# Access Compliance Report

## Public Rights-of-Way

### (Curb Ramps)

Intersection ID: 8014	Main Street: MORGAN_ST	Cross Street: SAMPSON_ST	Location:	N
ADA ID: BE6A26625461	Ramp Type: BlendTrans2	Initial Pass/Fail: Fail	Overall Compliance: No	Severity Score: 10

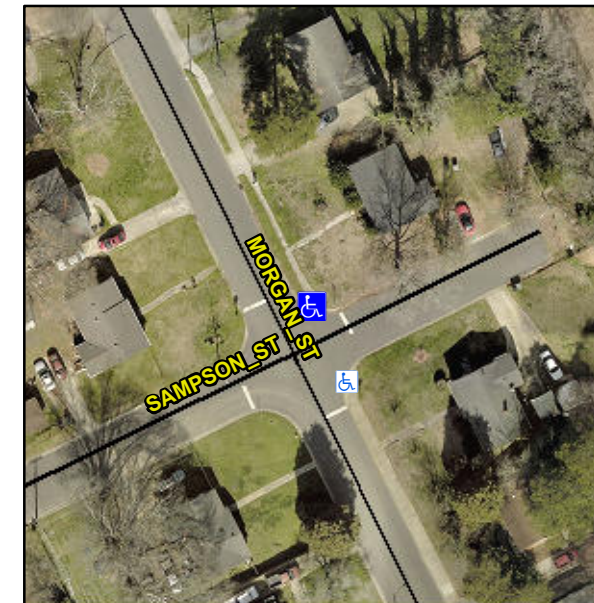
**NO RT SW**

**R304.5.1, R304.5.3**

Compliance	Description	Data	Compliance	Description	Data
N/A	Ramp Length (in)	84.0	Yes	BlendTrans Slope (%)	3.2
No	Ramp Width (in)	46.5	No	BlendTrans XSlope (%)	3.7
N/A	Flare Type LT	N/A	N/A	Flare Type RT	N/A
N/A	Flare Slope LT (%)	N/A	N/A	Flare Slope RT (%)	N/A
N/A	Flare Traversable LT?	N/A	N/A	Flare Traversable RT?	N/A
N/A	Landing Length (in)	N/A	N/A	DWS Provided?	N/A
N/A	Landing Width (in)	N/A	N/A	DWS Contrast?	N/A
N/A	Landing Slope (%)	N/A	N/A	DWS Length (in)	N/A
N/A	Landing X Slope (%)	N/A	N/A	DWS Full Width?	N/A
N/A	Landing Curb? (Y/N)	N/A	N/A	DWS Offset (in)	N/A
N/A	Shared Landing?	N/A			
N/A	Gutter Ponding?	N/A	N/A	Gutter Slope (%)	N/A
N/A	Gutter Lip Ht (in)	N/A	N/A	Gutter X Slope (%)	N/A
N/A	Painted X Walk1?	No	N/A	Painted X Walk2?	N/A
	X Walk 1 Direction	To SE		X Walk 2 Direction	N/A
	X Walk 1 Width (in)	N/A		X Walk 2 Width (in)	N/A
	X Walk 1 Slope (%)	2.5		X Walk 2 Slope (%)	N/A
	X Walk 1 X Slope (%)	0.6		X Walk 2 X Slope (%)	N/A

**Remove & Replace Curb Ramp With Two New Directional Ramps or Equivalent.**
